All Purpose Building Permit Application

Location/Address of Construction: 5	HILLCREST CIRCLE	
Total Square Footage of Proposed Structu	Square Footage of Lot 10,329	
Tax Assessor's Chart, Block & Lot Chart# Block# Lot#	Owner: CARLE BARBAZA GULBRA	Telephone:
Lessee/Buyer's Name (If Applicable)	Applicant name, address & telephone: M+M ZWDJSZLTZJ Zoj-329 -4875	Cost Of Work: \$ 40,000 Fee: \$ 303
Current use: Proposed use: CARACE MARCHE Project description: ADDITION TO	as prior use:	X24'169 gen plans
Contractor's name, address & telephone: 90 Phyll ST #1 Down Who should we contact when the permit Mailing address: 5 AME We will contact you by phone when the review the requirements before starting a and a \$100.00 fee if any work starts before	permit is ready. You must come in and any work, with a Plan Reviewer. A stop v	pick up the permit and
	LIDED IN THE CURNICCIONS THE DEDMIT W	ULL RE ALITOMATICALLY

Re: 5 Hillerest Circle/Gullbrand Job Specifications

Re: 5 Hillcrest Circle/Gullbrand Job Specifications/Ammended

EXISTING HOUSE
ADDITION SIDE
SCALE 1'= 1'

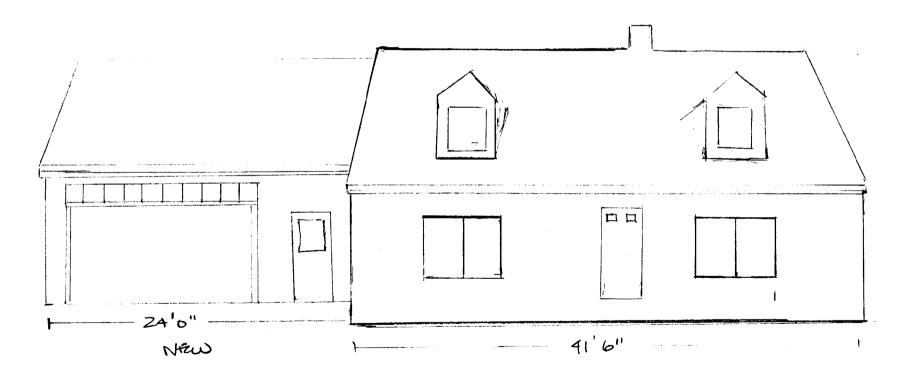
2X6 WAUS/ 2×10 200 FLOOR JOISTS ECRES WINDOWS L SIZE 30" X WISON 2X10 PARTER V 2X8 HEADRIN &XS NEW ADDITION 5/8" FITH COOK TO CARACKE 1ST RUDGE ENTRY PIRECOOK STEEL BIROLOS Par San ZNO W1430 STERL BRAM Need Spec EXISTING-Froom NEW COTTIGGA 1st floor GAZAGE Z41 137 EXISTING-HOUSE FLOOR رک 26'5" X 41'5" h-16' -1 18" TO MAKT SETBALL CARLA BALBARA GULBRAND 5 HILLERST CIRCLE FORTHUD, ME
